41 E. Main Street Tree Preservation Plan – TREE-13098

November 3, 2025

Tom Kiepura, City Arborist ISA #OH-6684A *TMK*

LOCATION: 41 E. Main Street – TREE-13098 (Tree is located in right-of-way on Division Street)

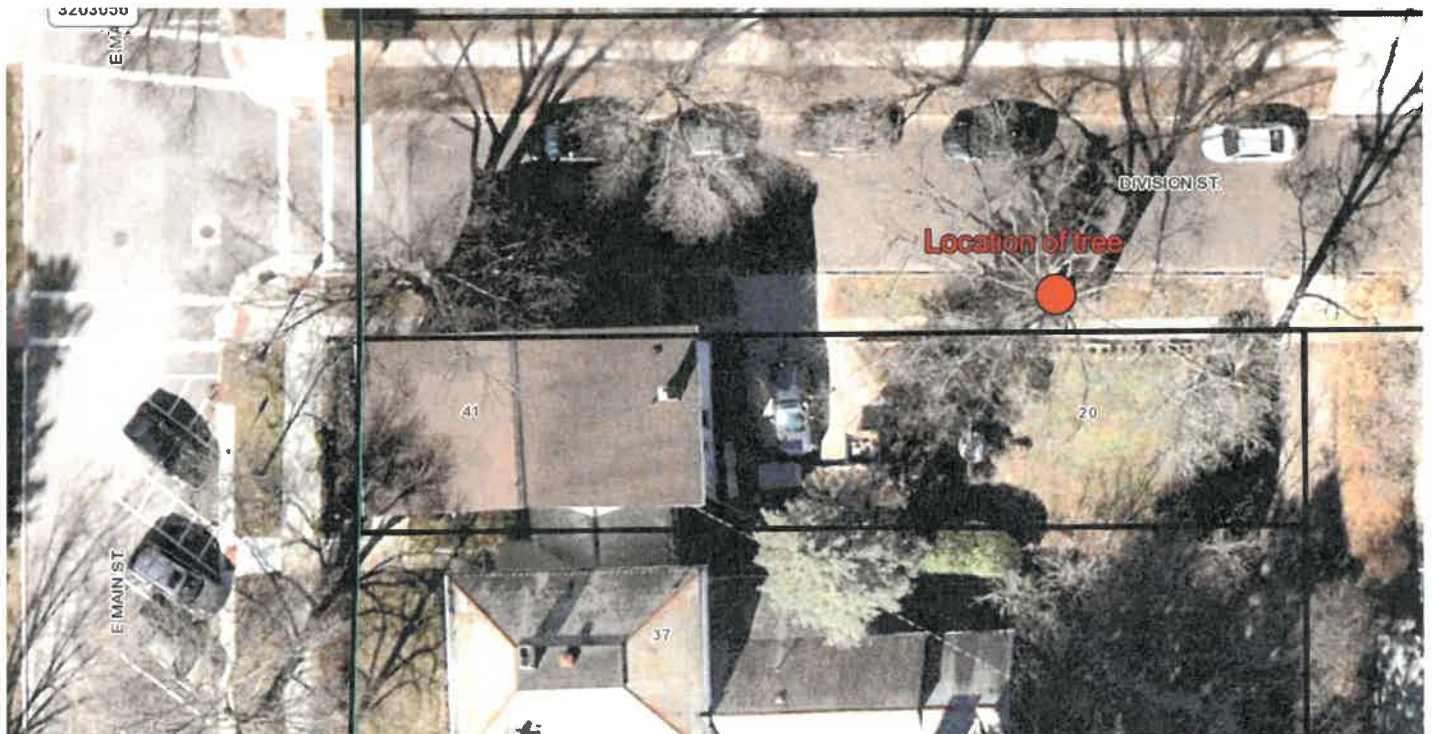
The proposed building addition at Village Dental, located at 41 E. Main Street, is likely to cause decline in the red oak (TREE-13098) located in the right-of-way on Division Street without adequate tree protection measures. Red oaks are known for being very sensitive to damage caused by construction activity. To mitigate the negative impact of this construction, I have put together a tree preservation plan that will give the tree the best chances of survival. If no tree protection measures are taken, I would expect the tree to decline slowly over a period of 3-5 years and eventually die.

The proposed construction, according to the revised plans submitted to the Arborist, would require excavation and removal of topsoil within the limits of the calculated TPZ. Specifically, a trench would be dug for the footer for the proposed building, and topsoil removed for the installation of a paver patio. It should be noted that most of the fine roots that provide water and nutrient uptake exist in the uppermost soil profile and will be removed along with the topsoil. It is presumed that this excavation would then be backfilled with a limestone base. The proposed patio is approximately 135 square feet.

In an effort to preserve the tree, **I recommend both a low-nitrogen fertilizer and phosphorus acid formula (such as Forti-phite) be injected into the soil under the tree up to the dripline via deep root fertilization between late fall and early spring.** This application should be made before any other tree protection measures. In addition, **I recommend the area around the root flare in a 6-foot radius be cultivated with an air knife and the soil amended with biochar, organic mulch, arborist wood chips and C20 Soil Builder.** Forti-phite, fertilizer application, and soil amendments will help prepare the tree for stress induced by loss of root volume. These applications are to be made by a Certified Arborist.

I propose that at the limits of disturbance, prior to construction, any roots that are to be cut shall be exposed with an air spade and cut cleanly with a saw. This root pruning should take place

between November 1st and March 1st. These cut roots shall be promptly backfilled with soil to prevent desiccation. This work is to be performed by a Certified Arborist.

I also propose a tree protection barrier be installed prior to any construction activity. This barrier (a fence) excludes access to areas within the calculated tree protection zone that are outside of the limits of disturbance. **There shall be no soil cuts or fills, or otherwise change of grade within this tree protection barrier. No construction activities, staging, storage, or otherwise utilization of this space shall occur for the duration of project. This includes trucks, heavy equipment, and construction materials. The deep root fertilization, root invigoration, root pruning, and installation of the tree protection barrier shall be subject to inspection by the City Arborist.**

I also propose that the landscape plan be revised to include as much mulch area (instead of lawn) as possible under the dripline of the tree. Turfgrass competes for resources (water and nutrients) and a reduction in lawn area will reduce said competition. The area underneath the dripline of the tree should be irrigated with an appropriate amount of water (1 inch per week) during times of drought so as not to further stress the tree. Irrigation should be deep and infrequent. This practice should continue until the tree has adjusted to any root loss it has experienced. This can take several years.

Additionally, some limbs will need to be removed above the proposed structure. This pruning shall be done by a Certified Arborist between October 15th and April 15th to minimize the chances of oak wilt infection. Pruning shall be kept to a minimum and only remove what is necessary.
